# Access Compliance Report

## Public Rights-of-Way

### (Curb Ramps)

Intersection ID: 17854	Main Street: HARDWICK_RD	Cross Street: N_SHARON_AMITY_RD	Location: SE
ADA ID: 80E272BB6438	Ramp Type: ParaDiag	Initial Pass/Fail: Fail	Overall Compliance: No
Codes/Mitigation Info/Possible Solution		Field Measurements/Component Compliance	
Severity Score: 13.75

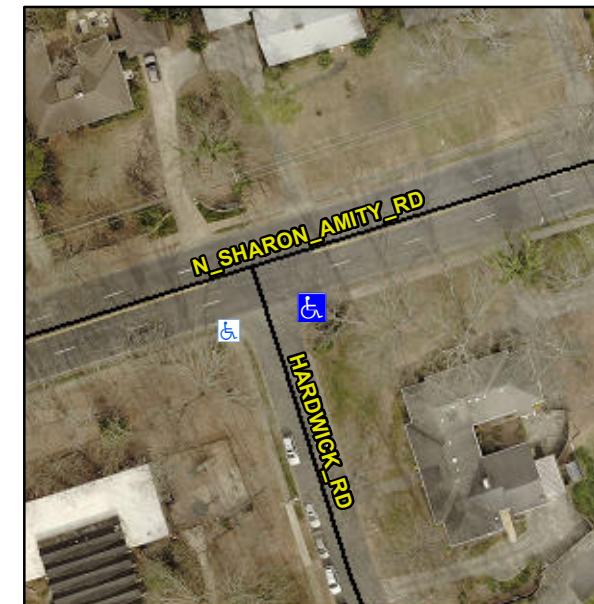
**LT RP < 5%**

**R304.5.3, R304.3.2**

**Remove & Replace Curb Ramp With Two New Directional Ramps or Equivalent.**
